## CITY of NOVI CITY COUNCIL

**Agenda Item 1**  
**August 13, 2018**

**SUBJECT:** Approval of the request of Erickson Living for the revised Special Land Use permit, Revised Preliminary Site Plan with PD-1 Option (and associated Fourth Amendment to the Development Agreement), Revised Phasing Plan, Revised Wetlands Permit, Revised Woodlands Permit, and Revised Storm Water Management Plan, JSP 18-19. The property is located on the north side of Thirteen Mile Road, west of M-5 and east of Meadowbrook Road. The applicant is proposing to revise the original approval and layout of the addition to the Continuing Care Center at the Fox Run Senior Community in Phase 4. The addition would result in 90 new assisted living units along with dining, gardens and enrichment facilities.

Drawing  
**SITE PREPARATION PLAN**

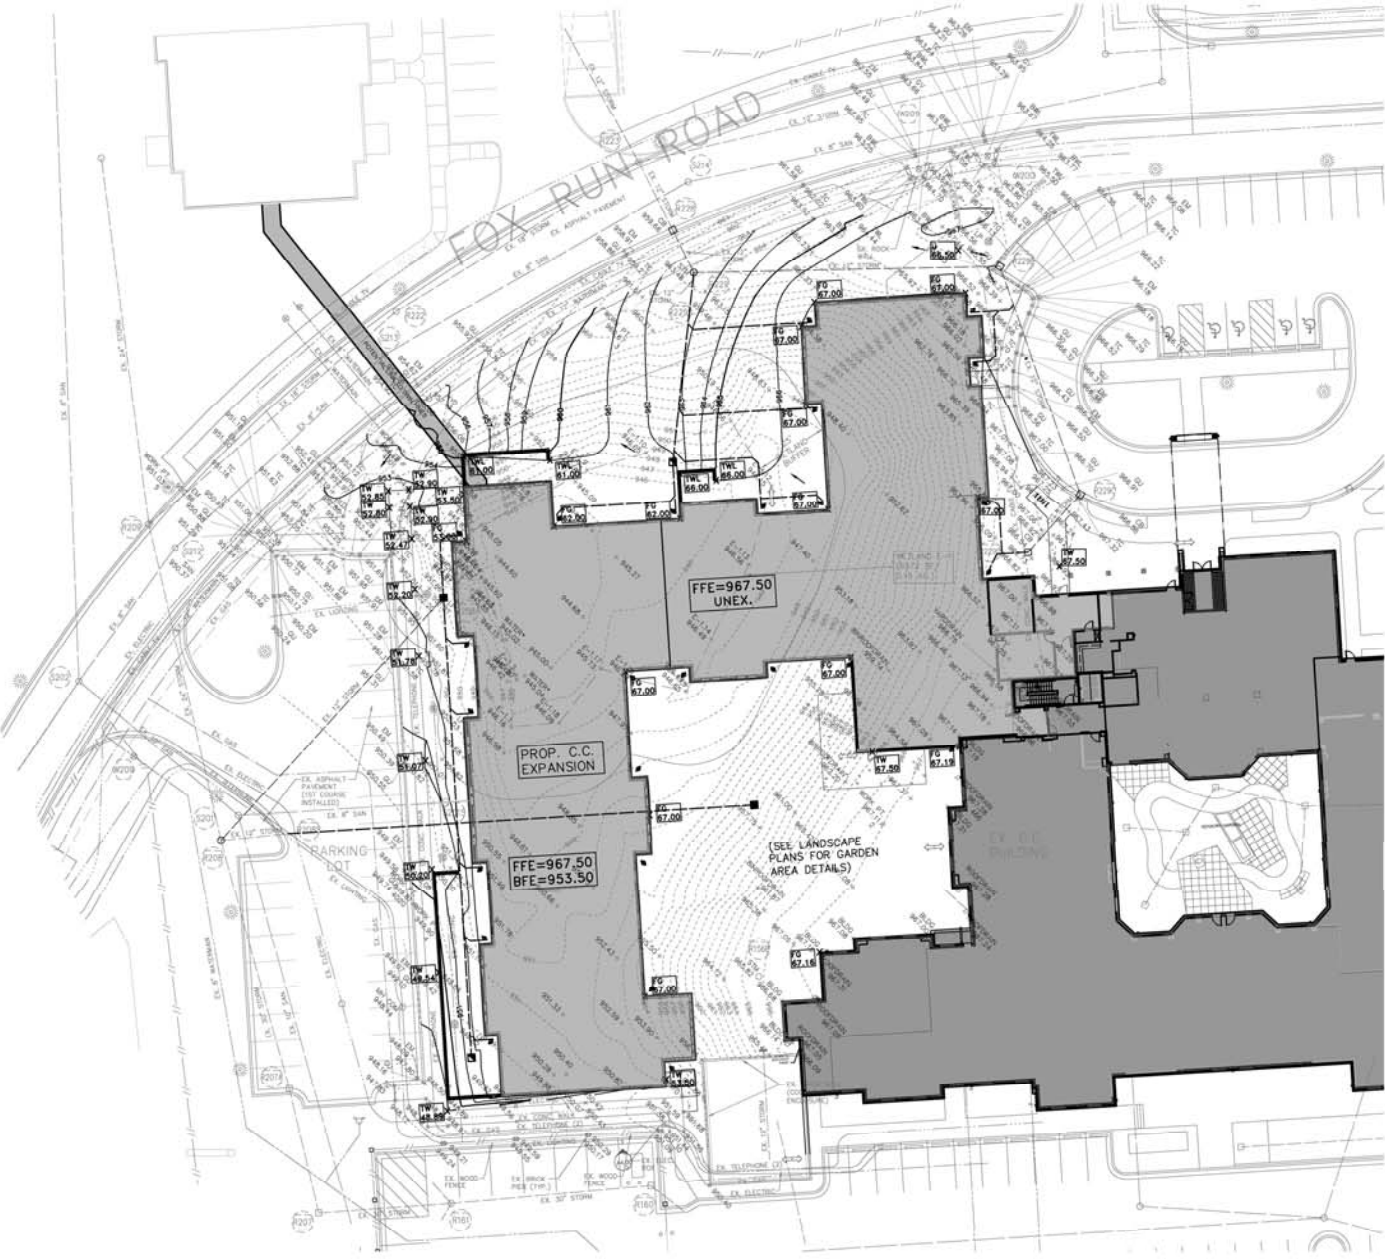
8. Revise Casing Detail notes as necessary to be applicable to proposed use.
9. Clarify existing end section invert in the wetland and add R156B to the structure table on Sheet S101.
10. Adjust rim elevation of R229 to correspond to surrounding grade. Add any adjustment work to the Utility Plan and Grading Plans.

8. The Casing Detail on Sheet C107 has been revised.
9. The inverts on the existing end section R208A and CB R156B have been added to the Structure Table on Sheet S101.
10. The existing rim elevation of CB R229 shall be adjusted as noted on Sheets C102 and C103.

Drawing:  
SITE GRADING AND DRAINAGE PLAN

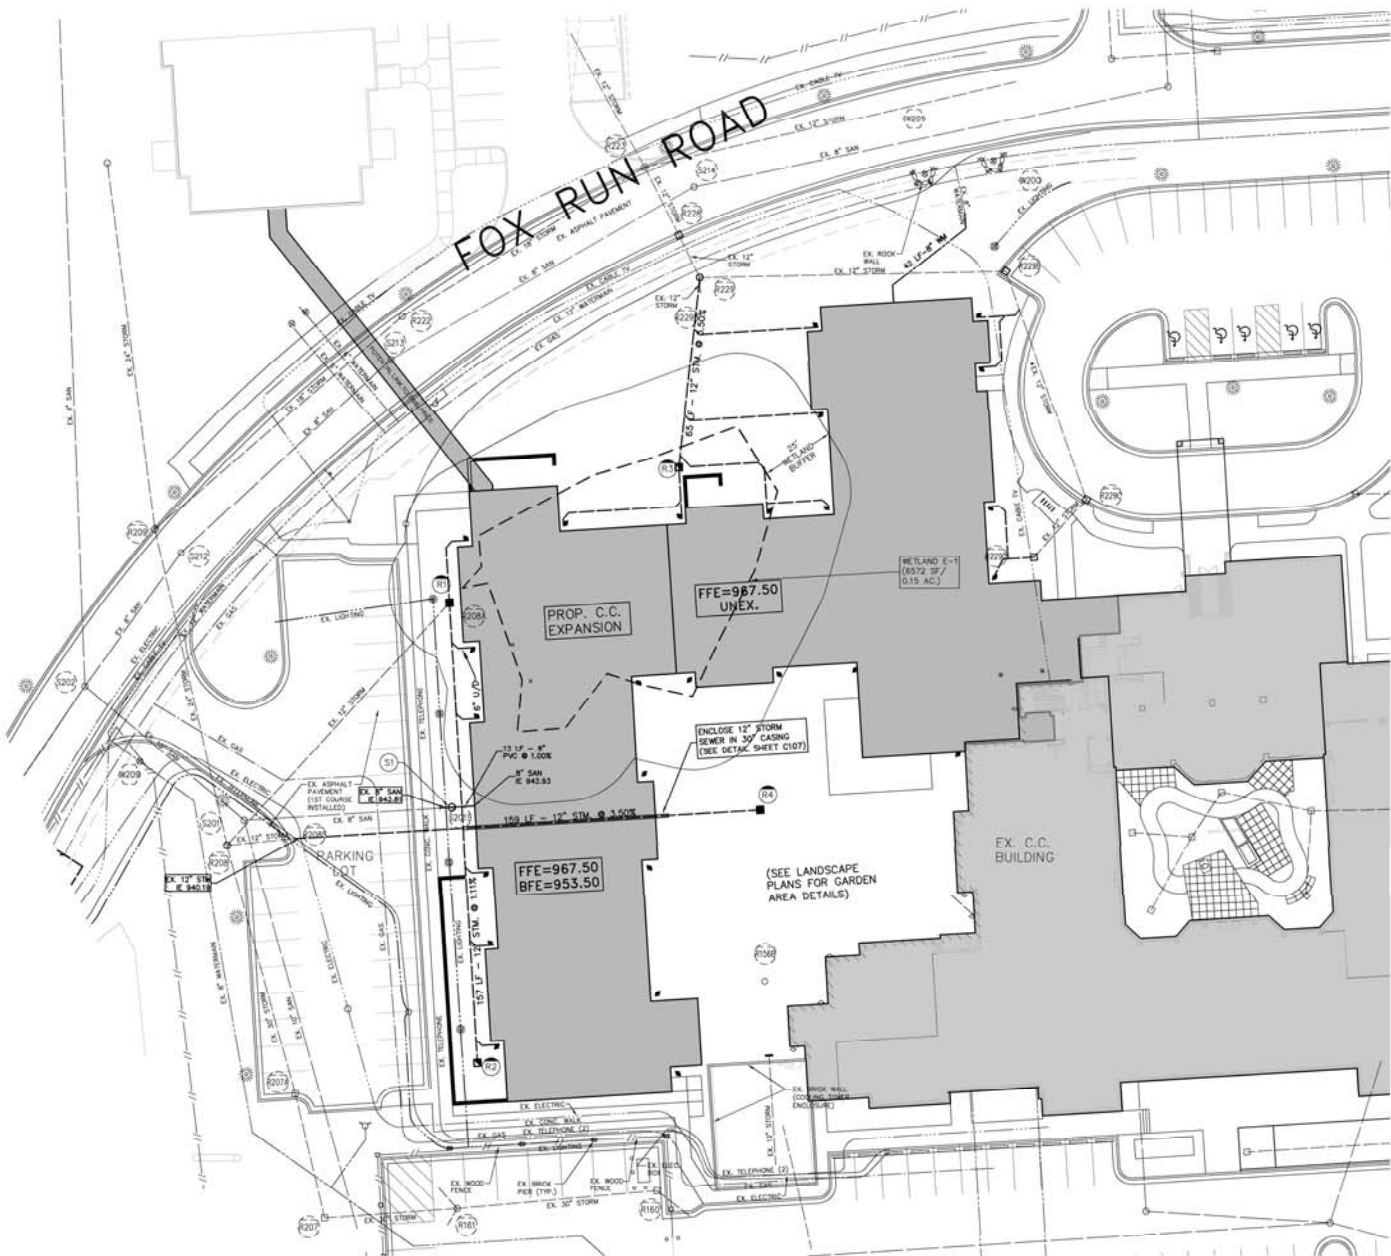
20. Indicate elevations of finished grades or rims of existing and proposed utility structures on the Grading Plan, specifically the protected light pole near R2, the proposed S1, and the proposed adjustment of the Com MH in the sidewalk.
21. The top lift of asphalt paving shall conform to current paving standards, 1.5 inches of 5E1. Refer to Detail 7C of the current City of Novi Paving Standard Details.

19. Finished grade elevations at the building corners and transitions have been added to Sheet C103.
20. Elevations on the existing and proposed structures have been added to Sheet C103.
21. The paving specifications has been revised to conform with the city' s current standard.
